SP1-13
105.3

Proposed Change as Submitted

Proponent: Jennifer Hatfield, J. Hatfield & Associates, PL, representing the Association of Pool & Spa Professionals (jhatfield@apsp.org)

TRANSFER SYSTEM PLATFORM AND STEPS

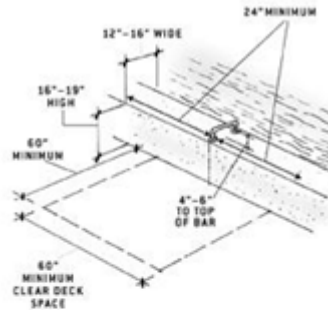
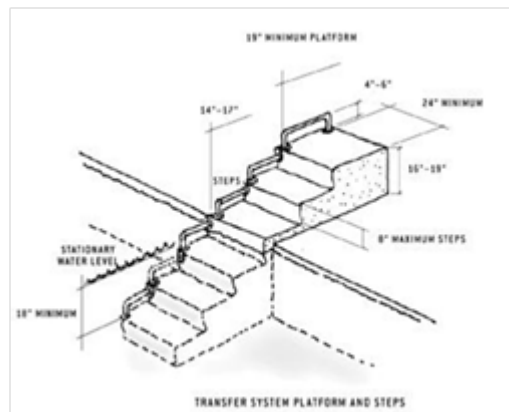
411.1 Entry and exit. Pools shall have not less than two means of entry and exit that are located so as to serve both ends of a pool. Pool lifts, transfer walls and transfer system that provide for pool entry and exit by persons with physical disabilities in accordance with Section 307.9 shall not be counted as a means of entry or exit ~~that is~~ required by this section.

Commenter's Reason: We wish to further modify what was already approved because there are other entry options provided for in ICC A117.1 (and ADA) for persons with disabilities. See the pictures below for graphics of the three types that would not work for general entry.

Section 307.9 references the IBC for accessibility, which in turn references the ICC A117.1 for technical criteria for these three types of entries.
